EXAMPLE #1

UNIVERSITY OF MICHIGAN
WILLIAM L. CLEMENTS LIBRARY INFRASTRUCTURE IMPROVEMENTS AND ADDITION
UM PROJECT NUMBER: P00001692
RIGHT OF WAY GRADING PLAN

ATHLETIC DEPARTMENT OPERATIONS CENTER

PRELIMINARY SITE PLAN REVIEW

SCALE HORIZ. 1"=20' VERT. 1"=2' | INCH 0 1
DRAWING NO. CG1.1
SHEET NO. ____ OF ____

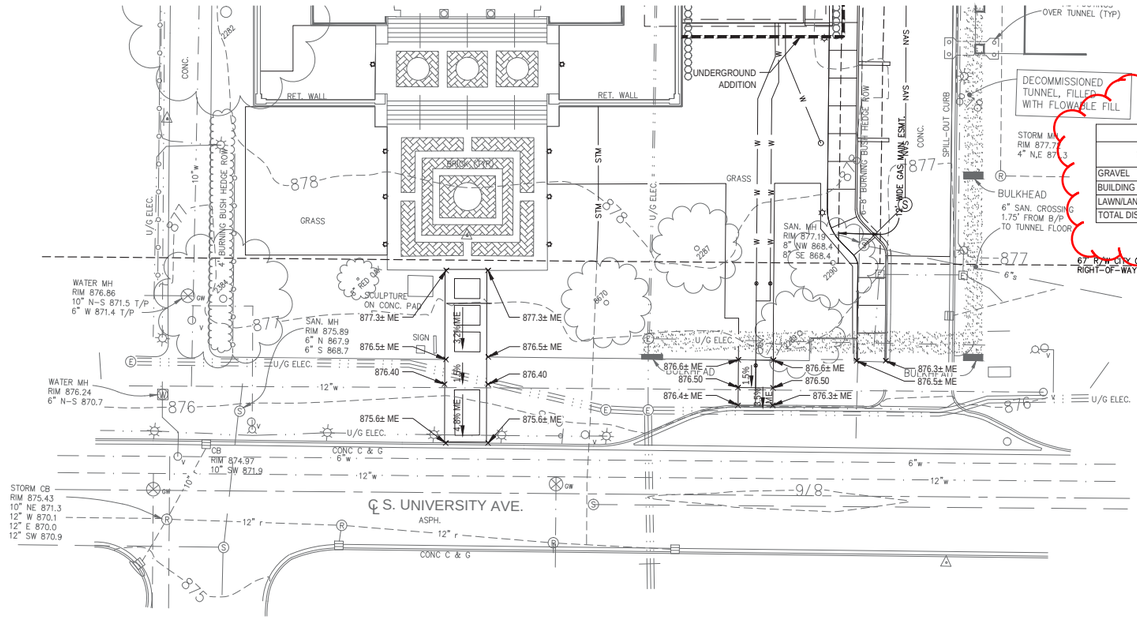
Show chart of with change in impervious -see attached example chart. Increase in impervious must be reviewed/approved by U-M Campus Planning and project team may be directed to design additional storm water management BMPs.

Provide a list of elective storm water BMP's to be installed and quantify benefits, if feasible.

Include the language: "Construction and operation of the storm water (infiltration/detention pond) or (BMP's on the plans) is/are in compliance with the requirements of State and Federal water pollution control laws."

Replace chart with format matching example chart below

sheet number: T-1C

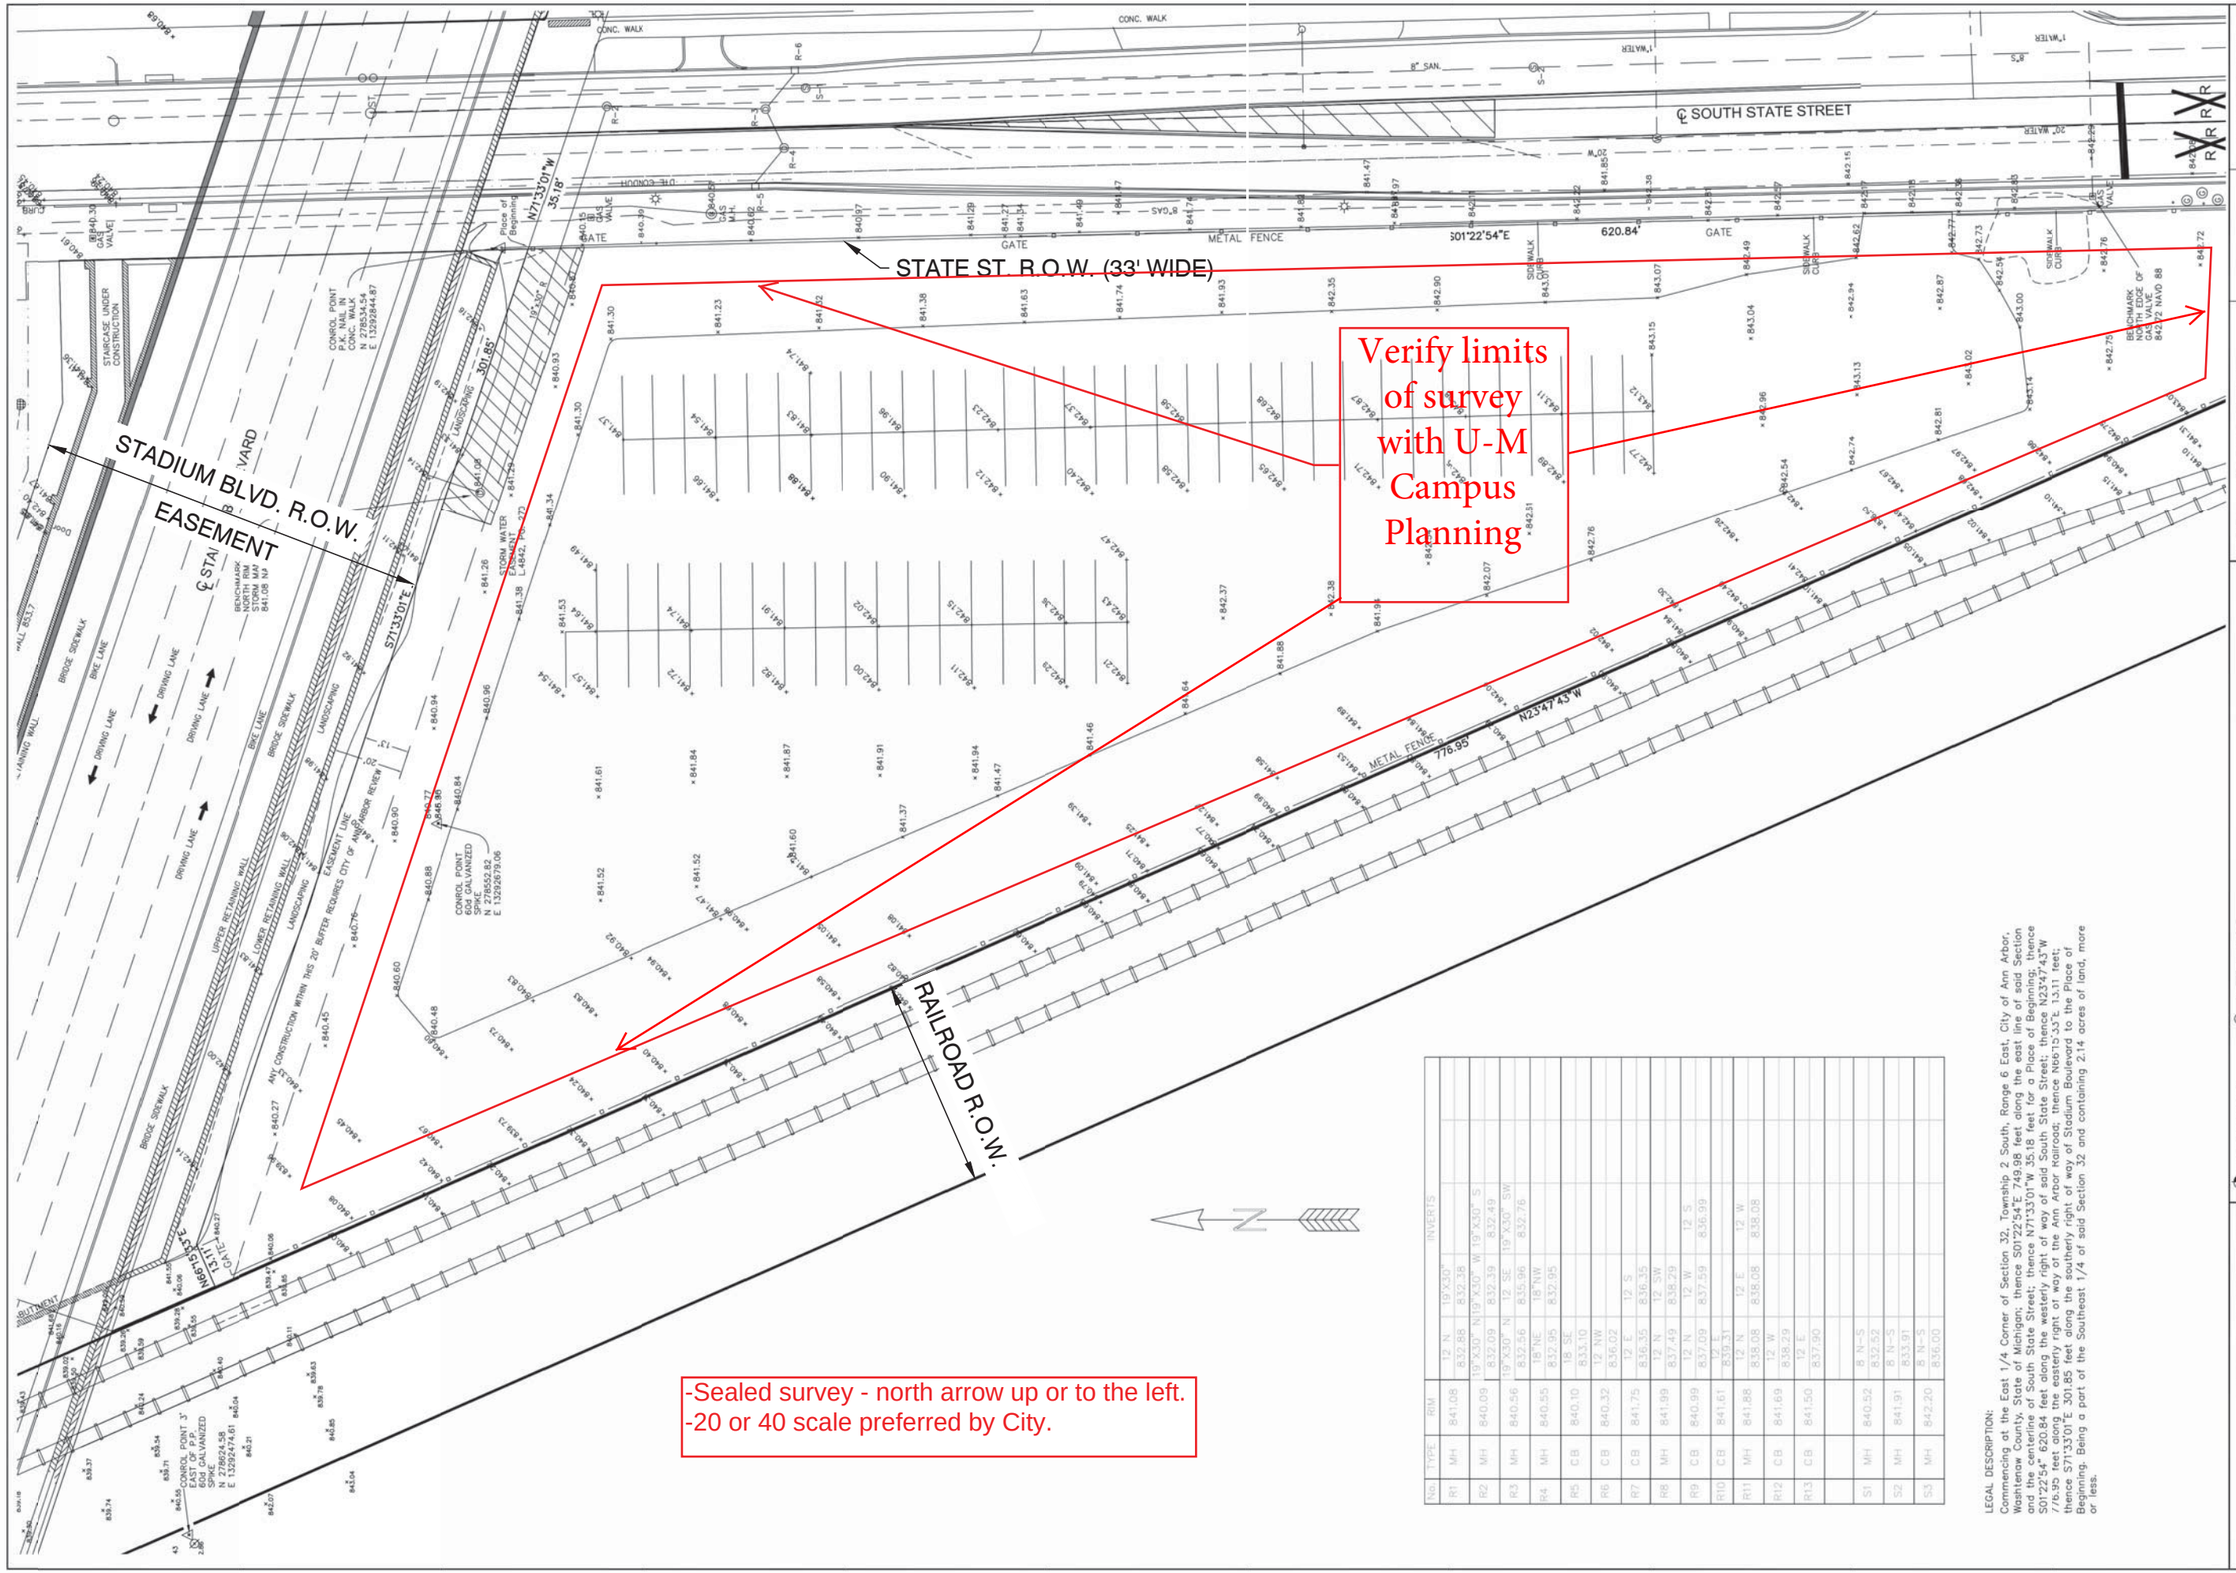
For City projects only - Title Sheet Listing type of City Review

C001C

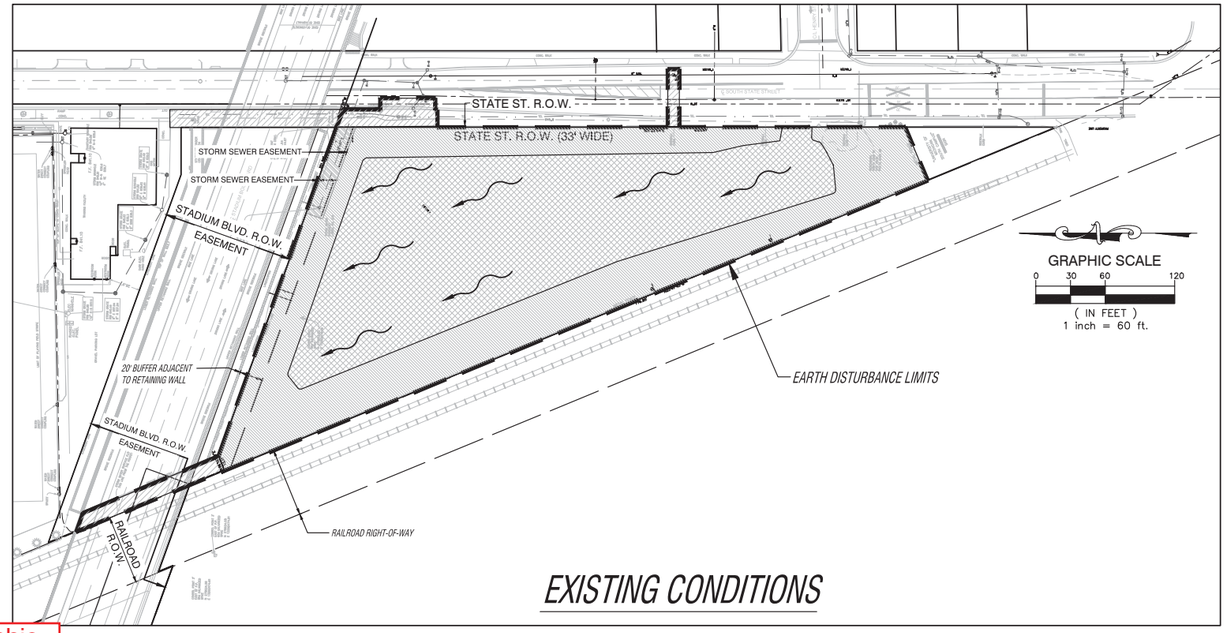
-Sealed survey - north arrow up or to the left.
-20 or 40 scale preferred by City.

PROPOSED CONDITIONS

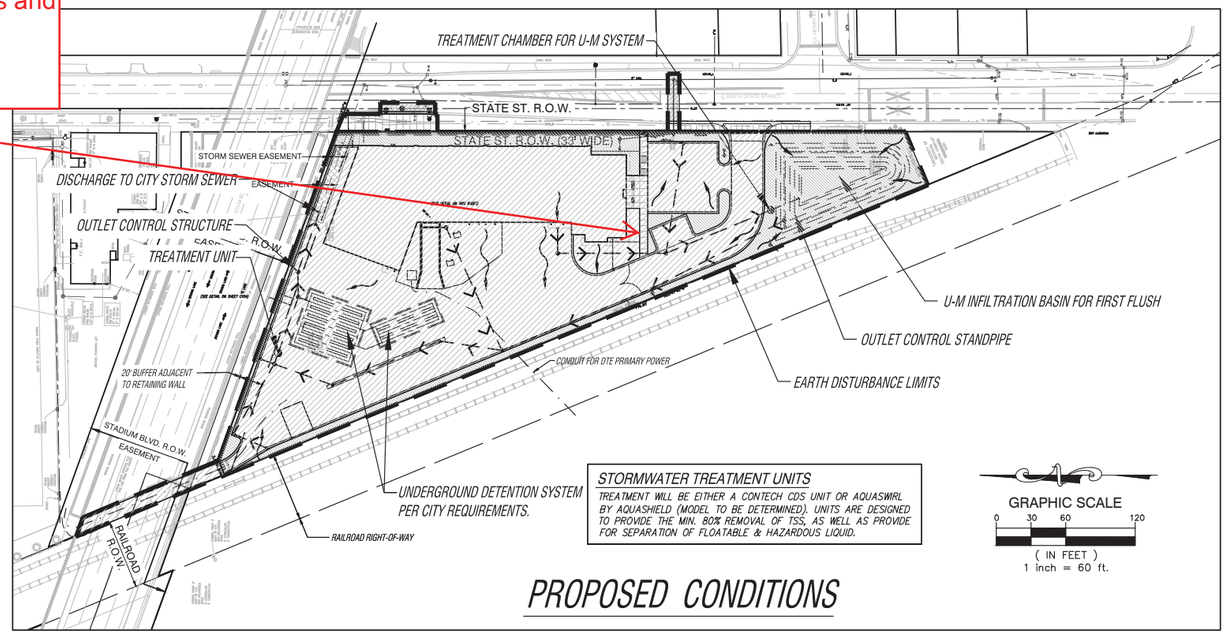
- Storm water sheet.
- Show drainage patterns of proposed and existing conditions with different hatching based on imperviousness. (See Campus Planning level of detail provided on U-M property)
-Provide narrative summarizing storm water as noted below.

Adjust this graphic to provide hatching of surface based on imperviousness and remove site paving details

project number: UM AEC : P00008399
sheet number: C104C

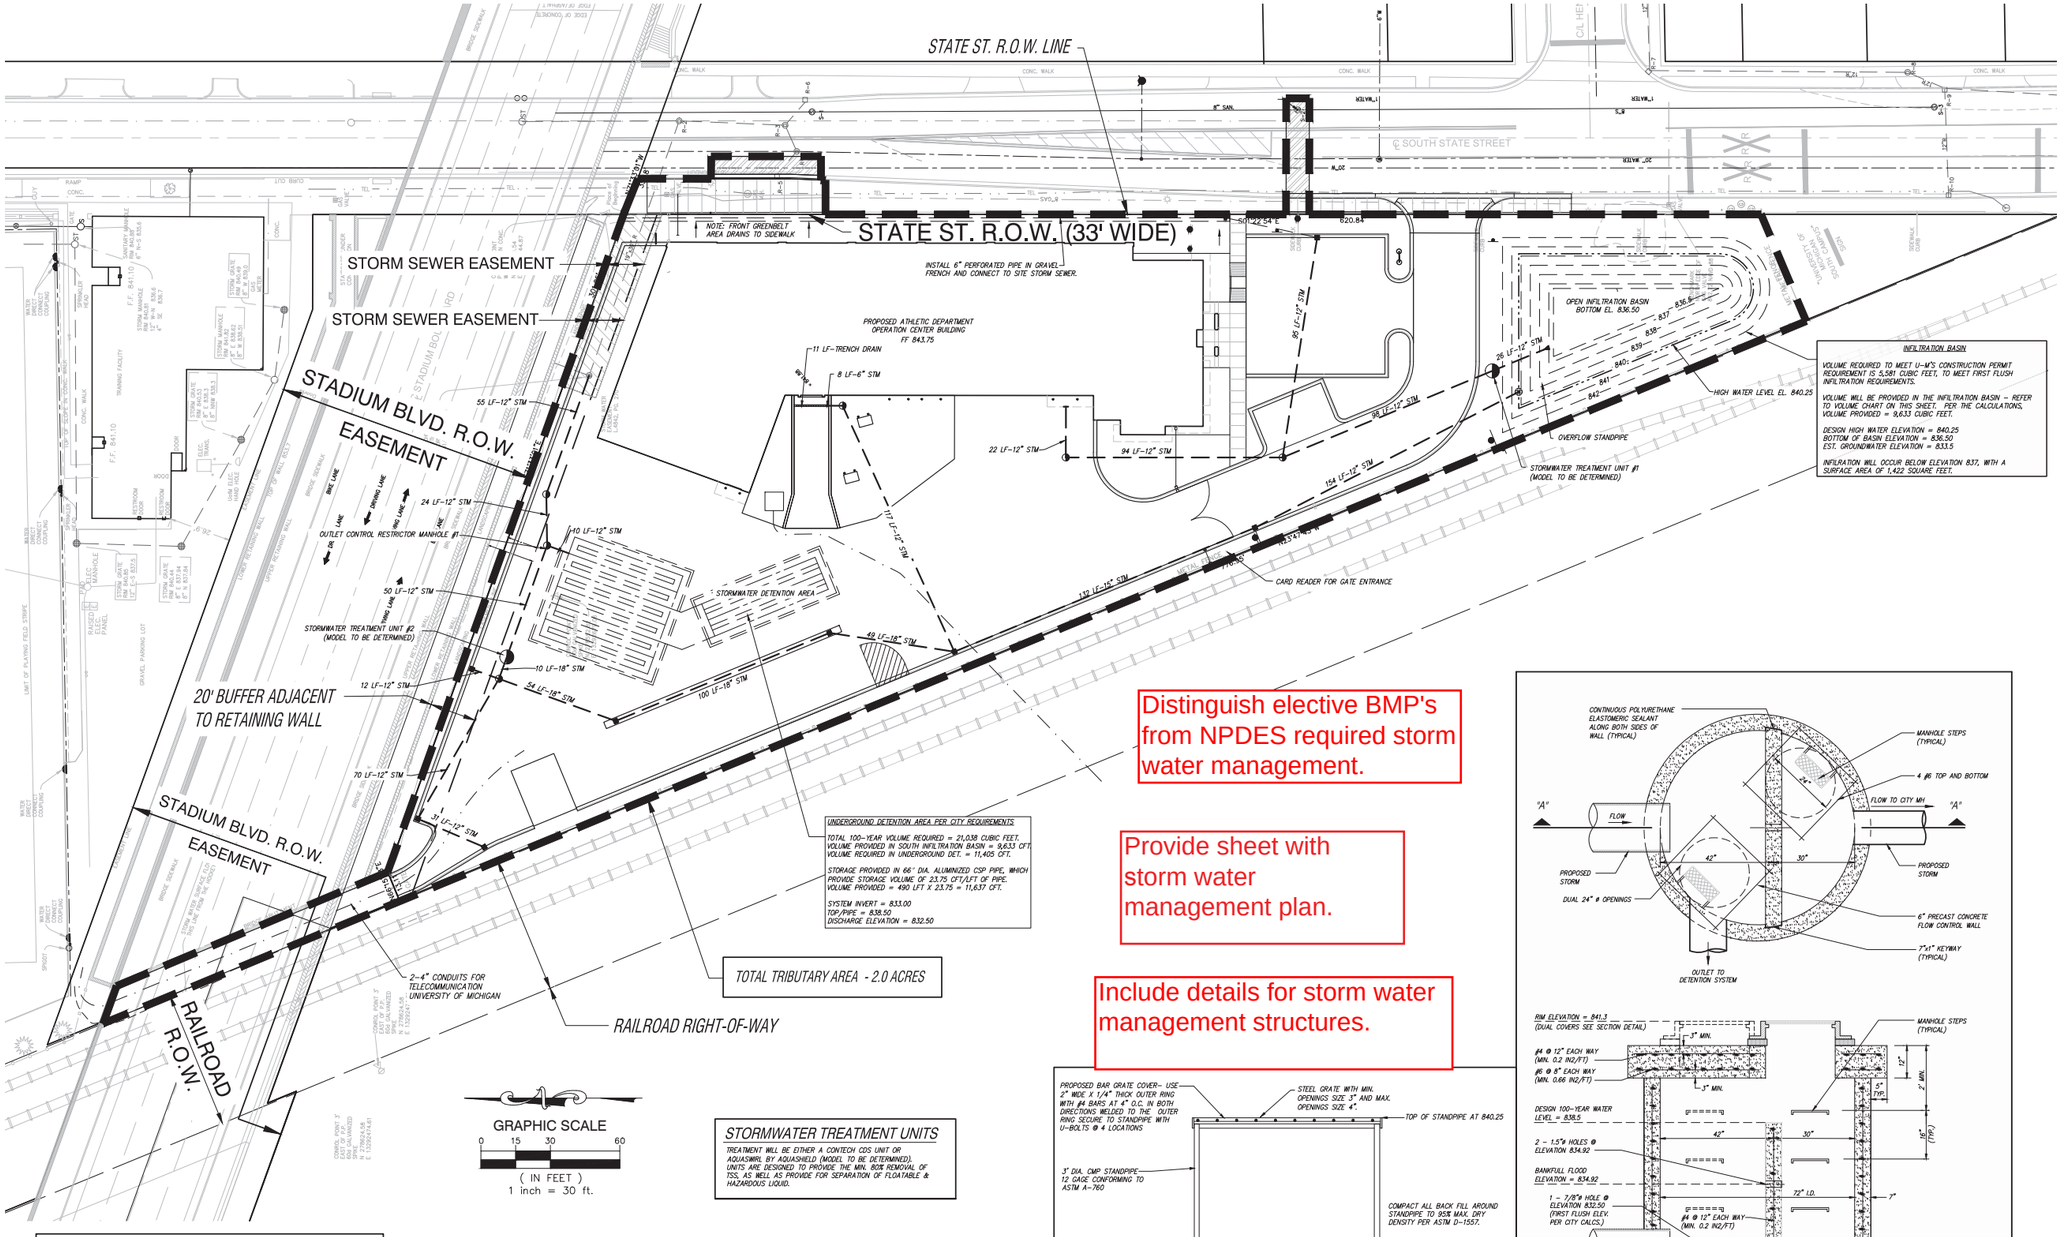
Distinguish elective BMP's from NPDES required storm water management.

Provide sheet with storm water management plan.

Include details for storm water management structures.

sheet number: C104AC

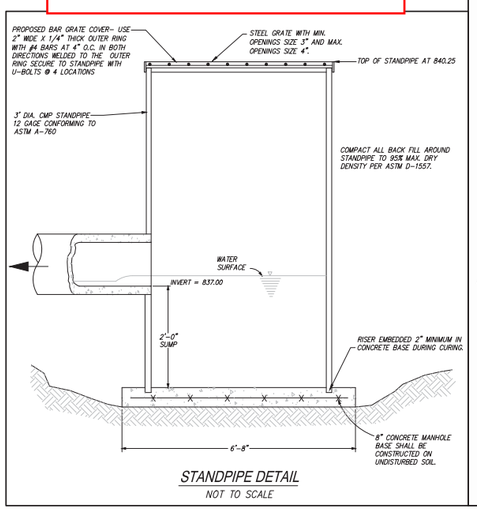
Provide calculation sheet.
